FAQ:

What are the significant changes between the 2018 and 2021 International Residential Code (IRC)?

This document includes a summary of significant changes to the 2021 International Residential Code (IRC) and includes the PA Uniform Construction Code Review and Advisory Council (RAC) Report Amendments. This document also provides further information for the identified code changes

FIGURE R311.7.4
WINDER TREAD AND LANDING DETAIL

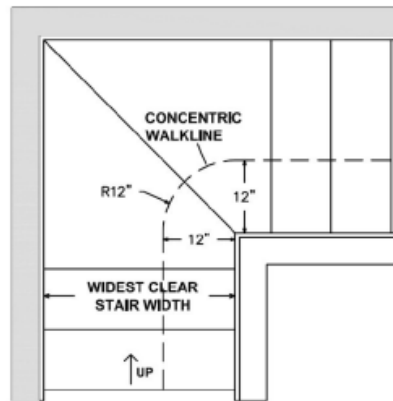
- **R311.7.4** - PA UCC RAC modifications to revise walkline requirements to the language under the previously adopted modification under the 2018 adoption.

R311.7.4 Walkline. *The walkline across winder treads and landings shall be concentric to the turn and parallel to the direction of travel entering and exiting the turn. The walkline shall be located 12 inches (305 mm) from the inside of the turn. The 12-inch (305 mm) dimension shall be measured from the widest point of the clear stair width at the walking surface. Where winders are adjacent within a flight, the point of the widest clear stair width of the adjacent winders shall be used.*
